Your ref: SSD-9358
Our ref: 12551870

Silverleaf Solar Farm (SSD-9358) – Response to Request for additional Information

GHD Pty Ltd has been engaged by ENGIE to respond on their behalf to your correspondence dated 19 October 2021 requesting additional information for the above application.

FIGURE 1

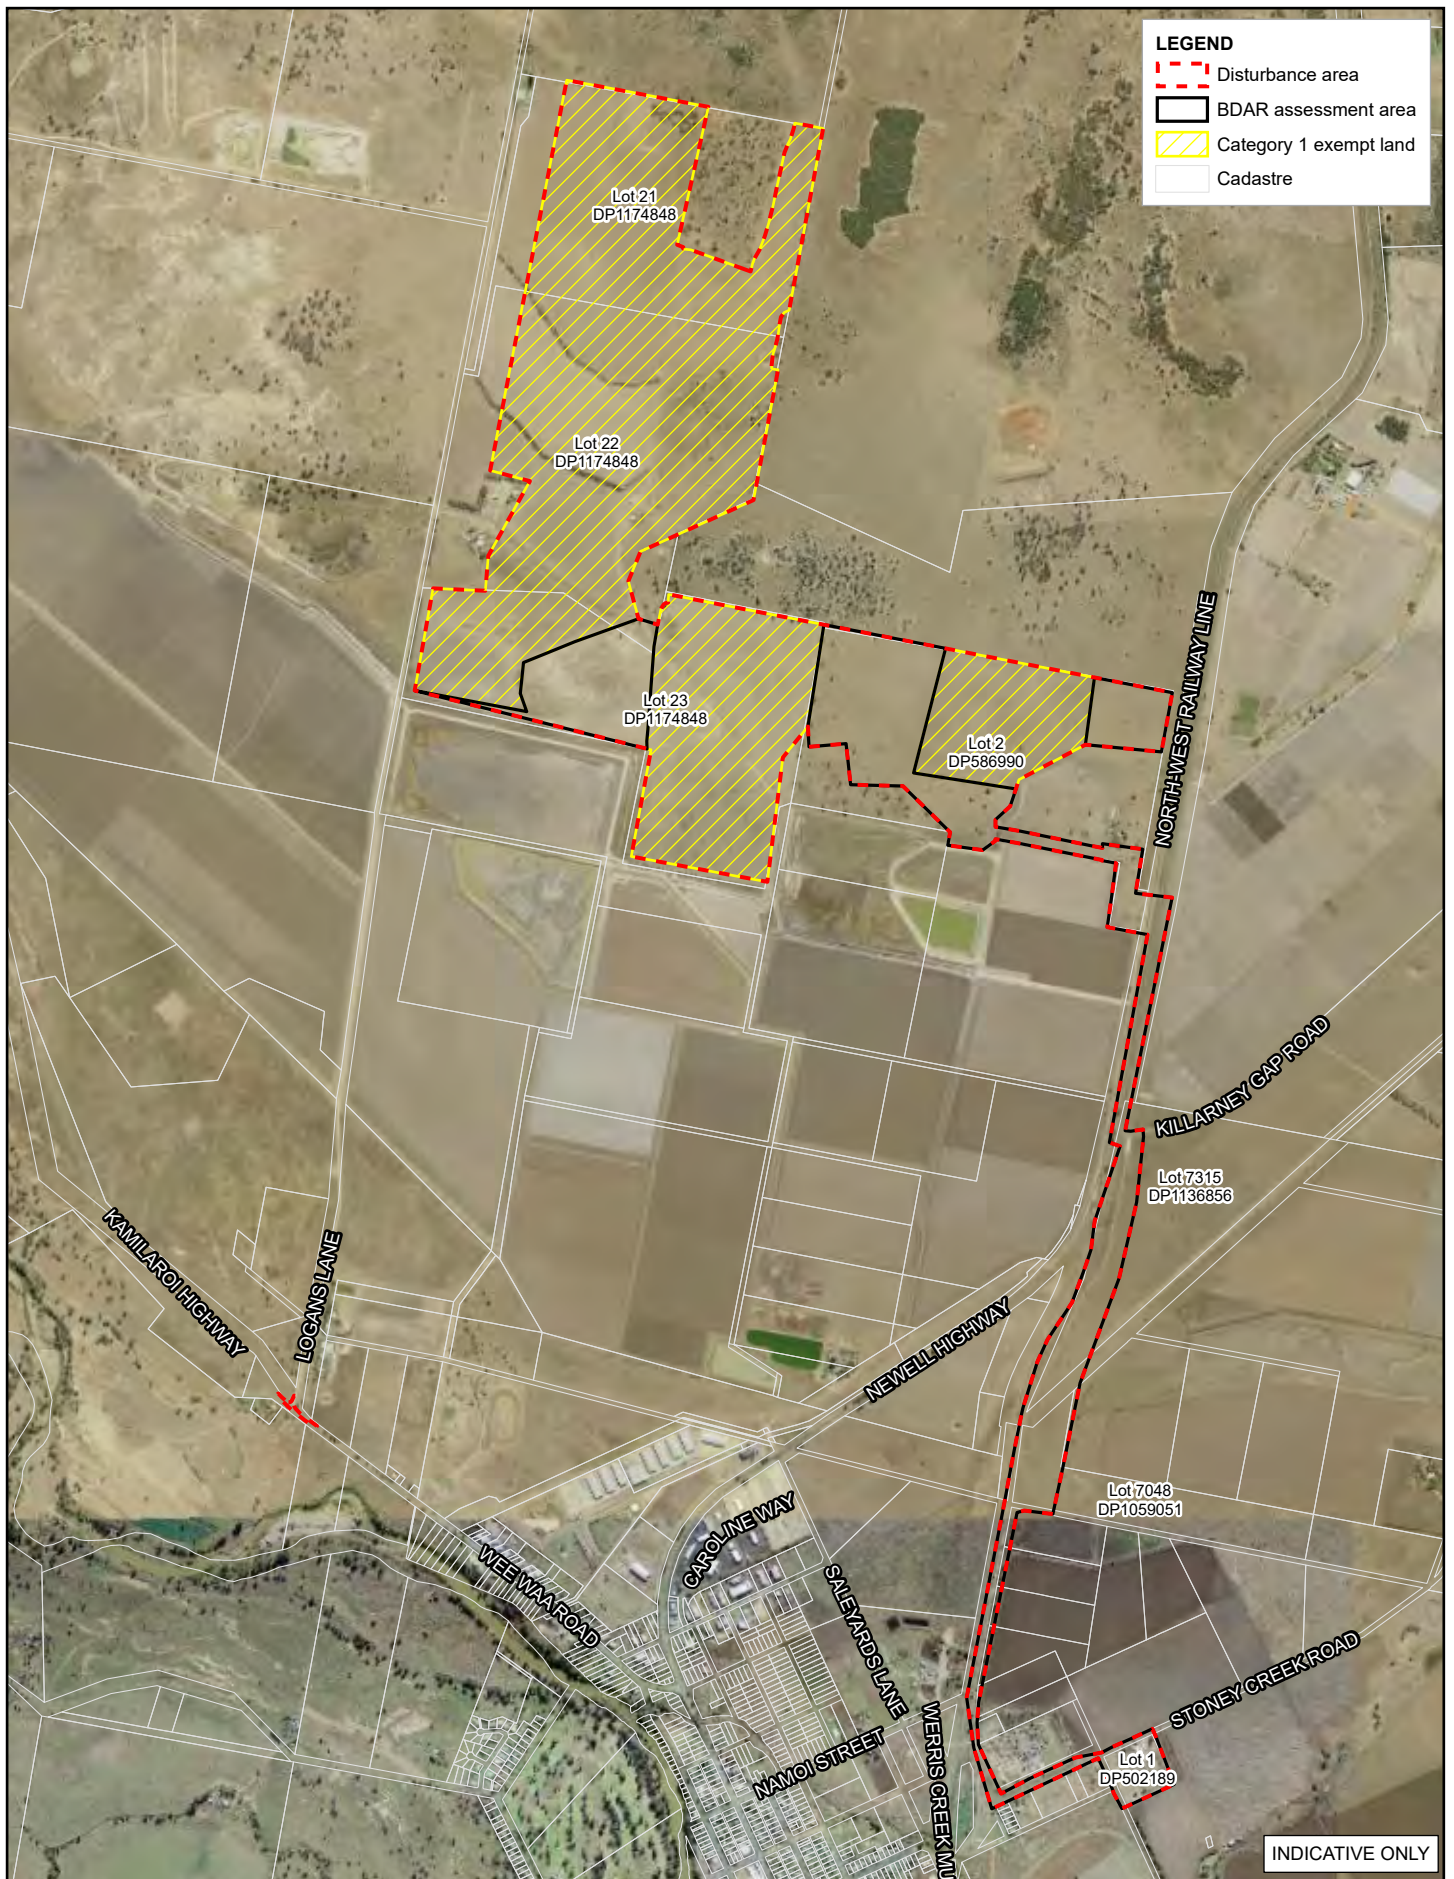
Confirm the project's area of disturbance, including shapefiles of the disturbance footprint

- *Clear definitions as to what the Project Site and Development Footprint entail (i.e. why they are different).*
- *Confirm the location of the area of PCT 397 avoided (see below for comments on figures as well).*
- *Confirm that 4.5 ha of the land mapped as BSAL and Class 3 within the project site is outside the disturbance footprint.*
- *Number of solar panels in the final proposed project.*
- *Number of inverter stations.*

The area of disturbance for the project is 396.9 hectares. This is the total area that will be disturbed to construct and operate the proposal and is comprised of the following:

- *Clearing area* which is the area of land where vegetation will be removed, this does not include the intersection upgrade area – 396.34 hectares
- *Category 1 exempt land* which is the area exempt from assessment in the BDAR – 285.18 hectares
- *Biodiversity assessment area* which is the area assessed in the BDAR and equals the clearing area minus the category 1 exempt land – 111.16 hectares

For further clarity, a figure (Figure 1) showing these boundaries is provided in Attachment 2.

As is common practice, the 'disturbance area' is predominantly referred to as the 'proposal site or footprint' in the EIS, Submissions Report, BDAR and the Amendment Report. This term could also be described as the 'development footprint' or 'project site'. For clarity, we are now referring to this area as the disturbance area as per the above request. The disturbance area (proposal site/project site/development footprint) is described above and shown in Figure 1 in Attachment 2.

FIGURE 4

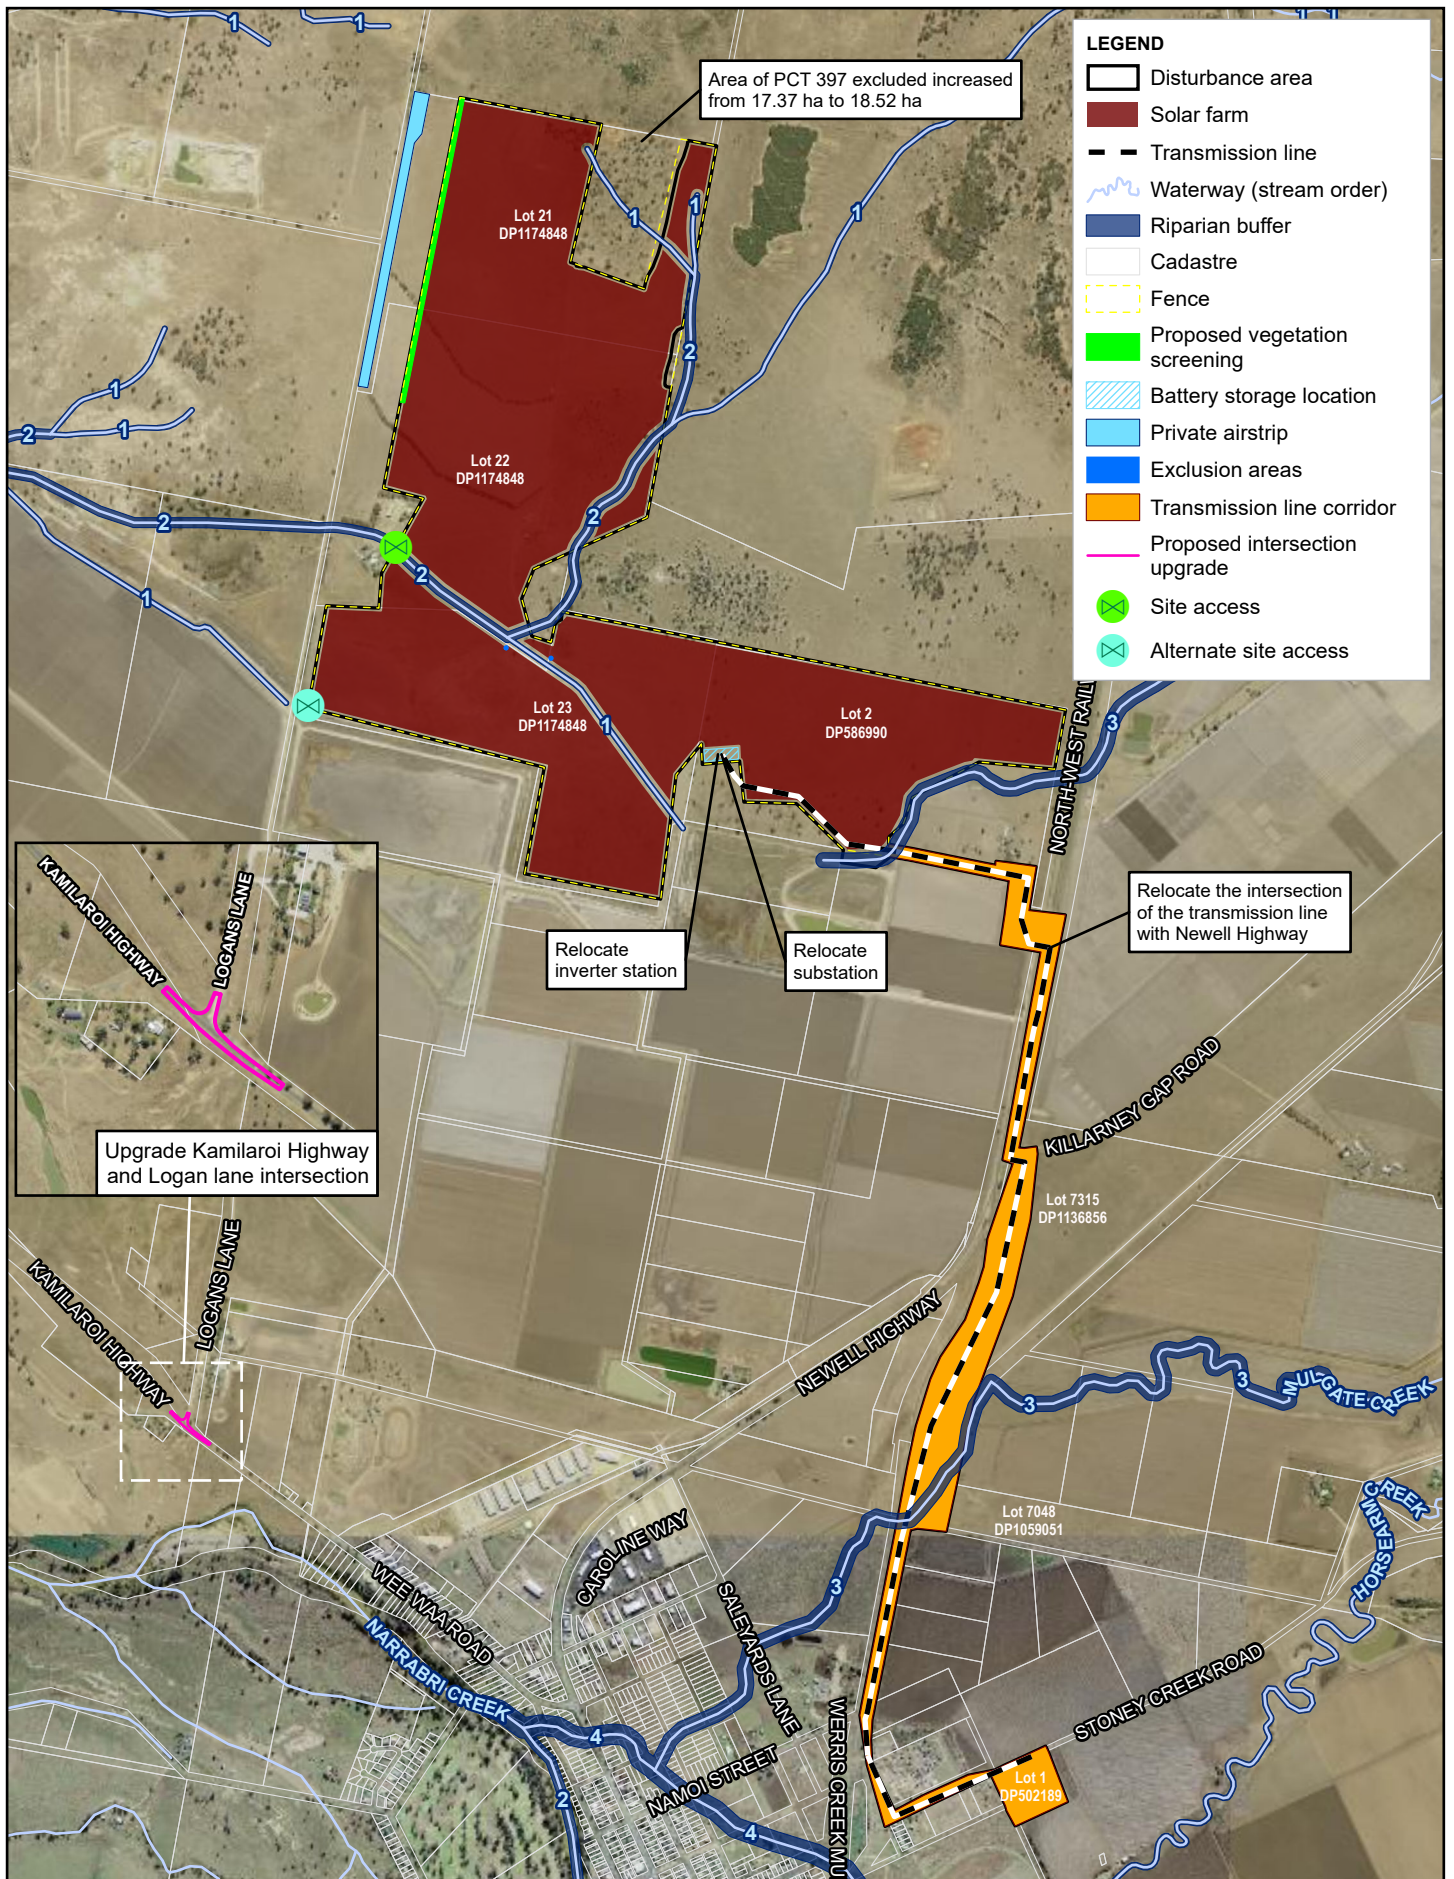
It is intended to use Engie's figures in the Assessment Report. Accordingly, send an individual pdf of just Figure 3-2 of the Amendment Report with the following detail:

- *Distinct boundaries of the Project Site and Development Footprint.*
- *Remove 'alternate site access'.*
- *Show the specific extent of riparian and water course buffer zones.*
- *Clearly show what changes occurred for the Amendment (i.e. understood to be reduction in disturbance of 6 ha and reduction in development site of 11 ha).*

An amended Figure 3-2 (Figure 4) highlighting the amendments referred to in the Amendment Report (and addressing your requirements above) is provided in Attachment 6. The following comments are made:

- The disturbance area is identified (project site/development footprint).
- The alternate access is retained as it would provide an additional access in case of limitations with the other access due to weather or any other issues.
- Proposed amendments are clearly labelled and include:
 - Upgrade of the intersection of the Kamilaroi Highway and Logans Lane.
 - Relocation of the proposed substation (and any co-located inverters) to the battery storage area. Other inverters would be situated throughout the array area.
 - Slight increase in the area of PCT 397 excluded from the clearing area (previously 17.67 hectares, now 18.52 hectares).

Buffer distances are unable to be discerned at the scale of the Figure 4 but the following has been applied for each waterway type:

- Steam order 1 20 metre buffer distance from the top of bank
- Steam order 2 40 metre buffer distance from the top of bank
- Steam order 3 60 metre buffer distance from the top of bank
- Steam order 4 80 metre buffer distance from the top of bank
